Project	CMHA Meadows RAD Renovations	Addendum Number	2
Project Number	18076.04	Date	09/12/2025
To	All Bidders		
<i>This addendum contains changes to the requirements of the bidding Documents, Project Manual and Construction Drawings which have been issued to date. Such changes are to be incorporated into the Construction Documents and shall apply to the work in the same meaning and force as if they had been included in the original documents. Wherever this Addendum modifies a portion of a paragraph of the Project Manual or a portion of any Drawing, the remainder of the paragraph or Drawing shall remain in force.</i>			
General	Clarifications: <i>Bid Form: See attached revised bid form showing line item for permit fee included.</i> <i>Do the gas lines in the laundry room need to be removed? Is the furnace the only gas fed item within the unit?</i> Response: Gas lines are stubbed into the laundry area for future use of a gas appliance. No work is to be done on the gas lines in the laundry room as a part of this renovation. <i>How should the curb be addressed where the sidewalk on the accessible route widens?</i> Response: See Civil drawings updates as a part of this Addendum. <i>Do y

THE MEADOWS RAD RENOVATIONS
4855 PINTAL CREEK DRIVE
COLUMBUS, OH 43210
FOR
**COLUMBUS METROPOLITAN
HOUSING AUTHORITY**

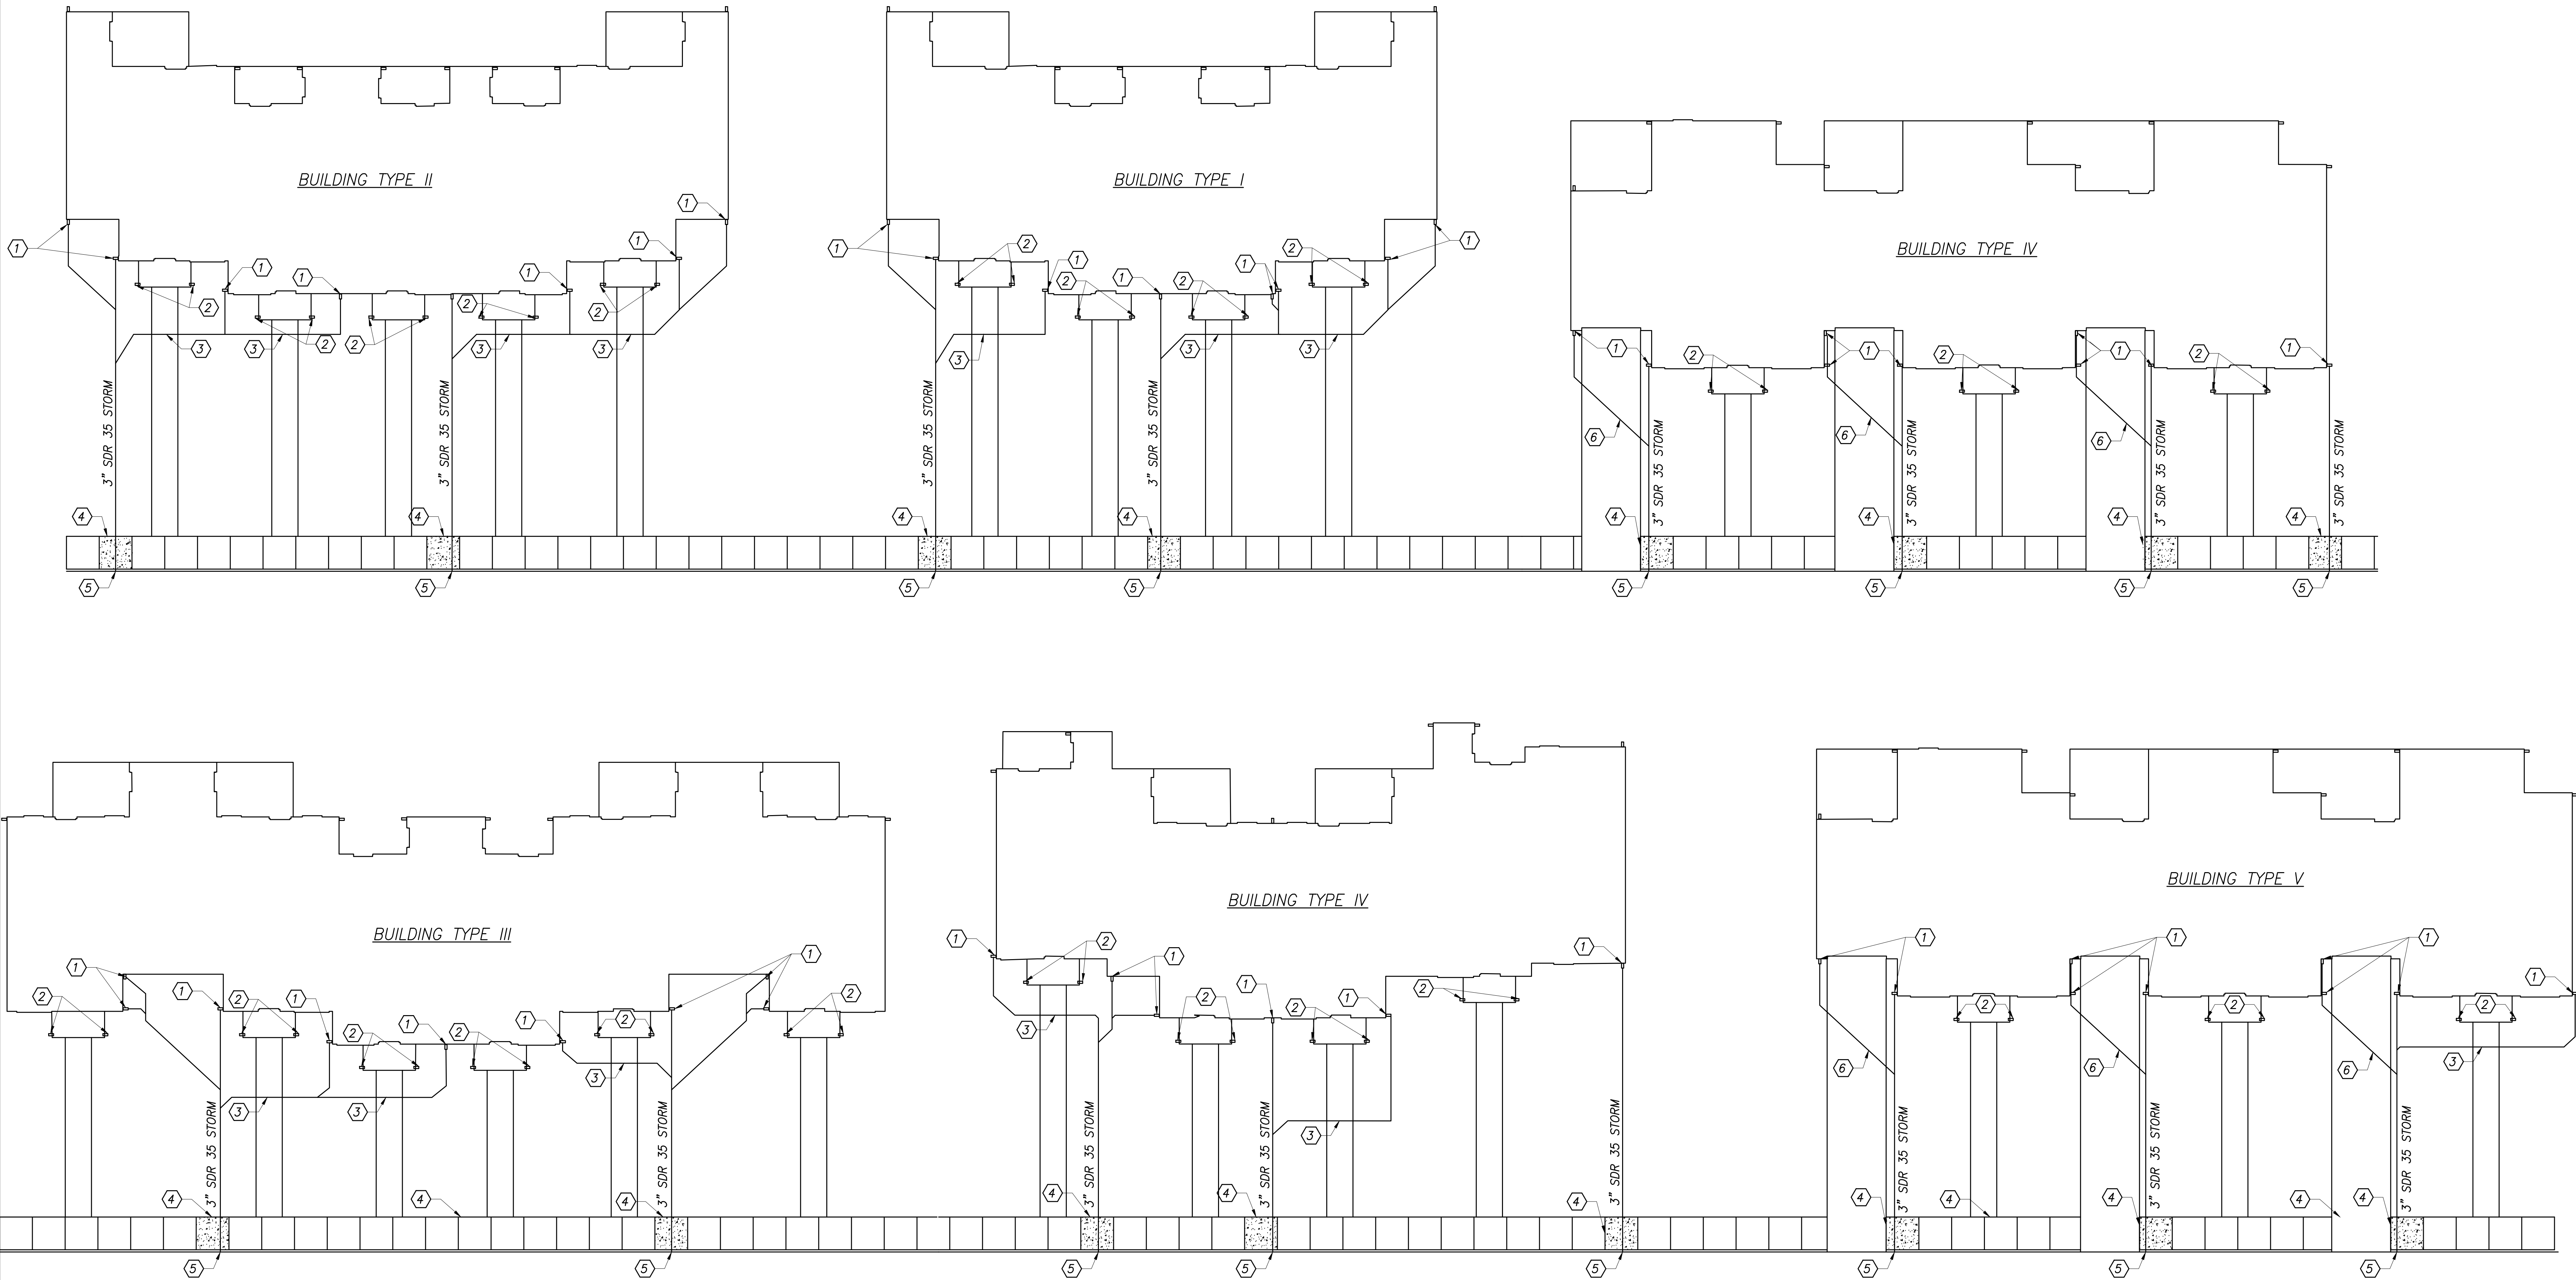
1. REVISED walk detail to include sawcut at curbline.
2. ADDED full depth pavement section.

Sheet C302 – DETAILS

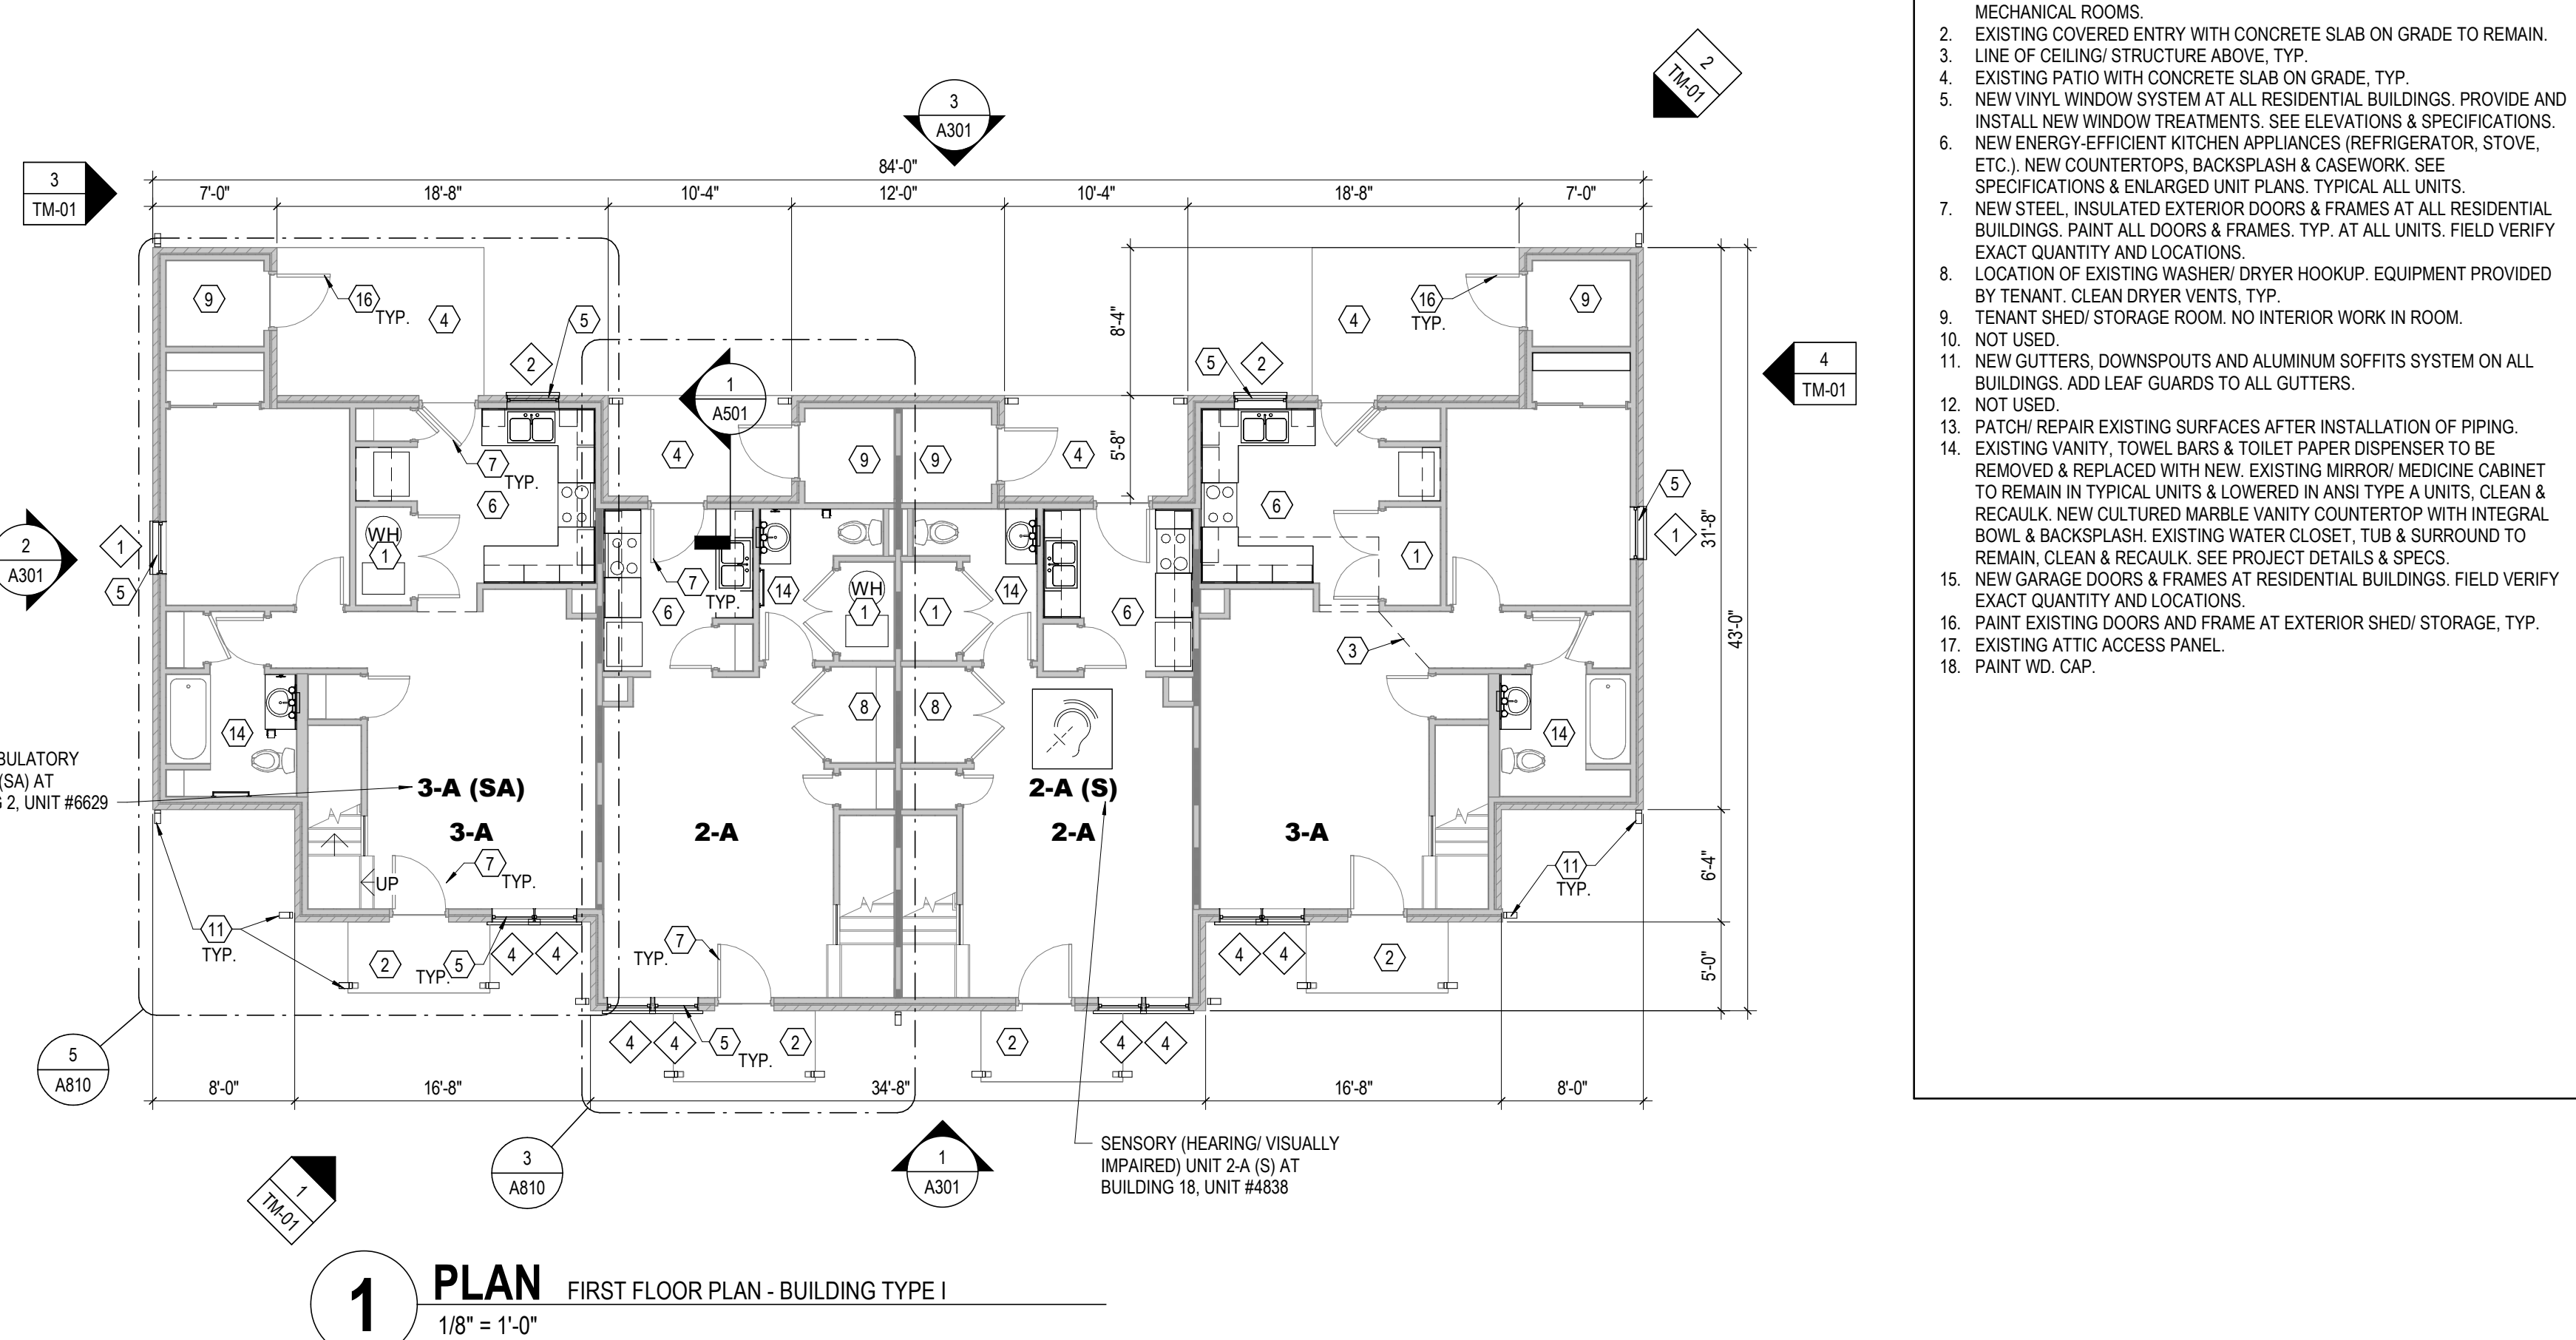
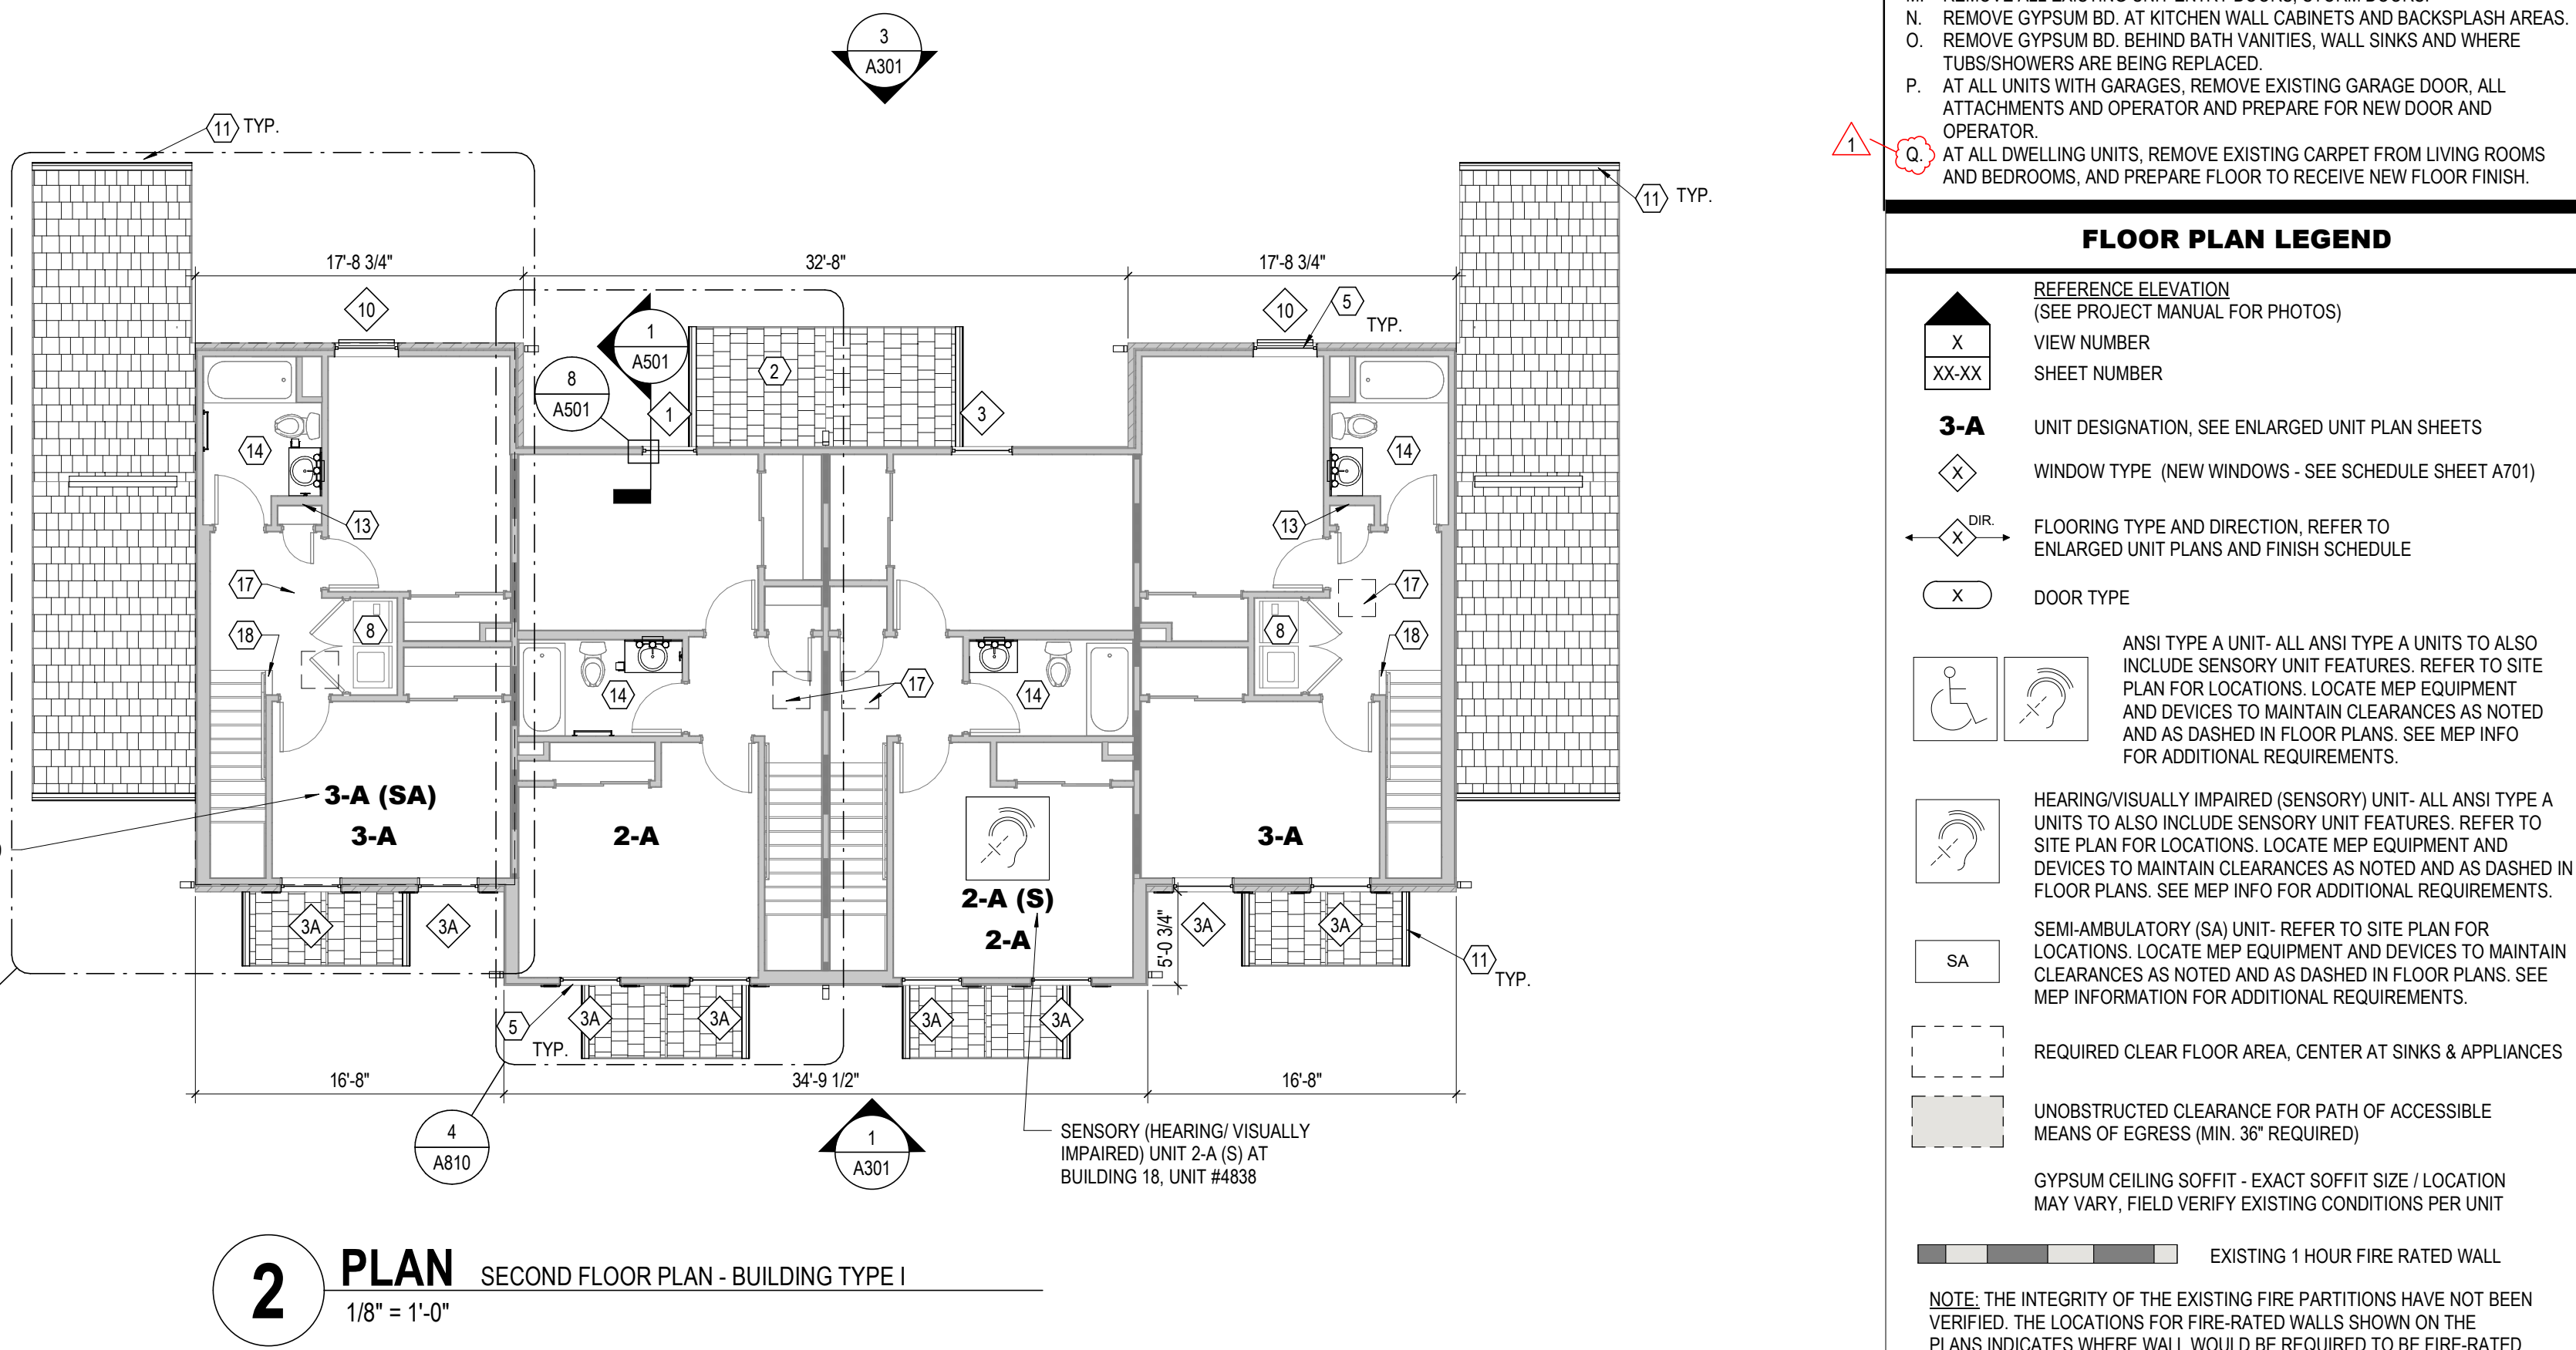
1. ADDED sheet.
